Document Control Desk Attachment I TSP 950011 RC-96-0109 Page 1 of 2

SCE&G -- Explanation of Changes Summary

SAFETY EVALUATION FOR REVISING THE CONTAINMENT LEAKAGE RATE TESTING SPECIFICATION IN THE VIRGIL C. SUMMER NUCLEAR STATION TECHNICAL SPECIFICATIONS

3/4 6-3

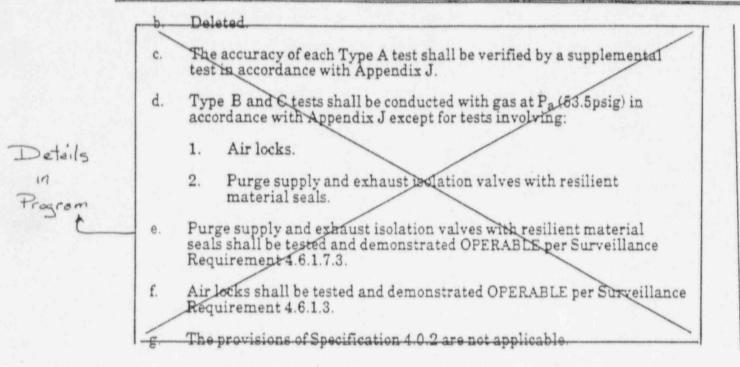
3.6.1.2	2	Reworded ACTION to address Mode restraints and completion times when leakage limits are exceeded.	Based on WOG guidelines for W PWRs, NEI and NRC model technical specification to implement Option B.

4.6.1.2 4.6.1.2.a	3	Removed "a." and reworded 4.6.1.2 to state "The containment leakage rates shall be demonstrated at the intervals derived through the Containment Leakage Rate Testing Program and shall be determined per the program criteria.".	This SR is addressed in the VCSNS Containment Leakage Rate Testing Program which implements the requirements of Reg. Guide 1.163 and ANSI/ANS-56.8-1994.
3/4 6-3	4.6.1.2.b 4.6.1.2.c 4.6.1.2.d 4.6.1.2.e 4.6.1.2.f 4.6.1.2.g	1	Removed from TS and relocated to the VCSNS Containment Leakage Rate Testing Program.	Relocation is based on model technical specifications to implement Option B. These SRs are addressed in the VCSNS Containment Leakage Rate Testing Program.
3/4 6-4	3.6.1.3	1	Removed "a." and "b." and reworded 3.6.1.3 to state "Each reactor building air lock shall be OPERABLE with both doors closed except when the air lock is being used for normal transit entry and exit through the containment, then at least one air lock door shall be closed."	Limits have been relocated to TS 6.8.4 under new segment "g." which has been added to describe the VCSNS Containment Leakage Rate Testing Program in accordance with the prescribed guidelines of NEI and WOG.

3.6.1.2. Containment leakage rates shall be limited in accordance with the Containment Leakage Rate Testing Program.

With the measured overall integrated containment leakage rate exceeding 1.0 L_a , within 1 hour initiate action to be in HOT STANDBY within the next 6 hours and in COLD SHUTDOWN within the following 30 hours. Restore the overall integrated leakage rate to less than or equal to 0.75 L_a and the combined leakage rate for all penetrations subject to Type B and C tests to less than or equal to 0.60 L_a prior to increasing the Reactor Coolant System temperature above 200°F.

4.6.1.2 The containment leakage rates shall be demonstrated at the intervals derived through the Containment Leakage Rate Testing Program and shall be determined per the program criteria.
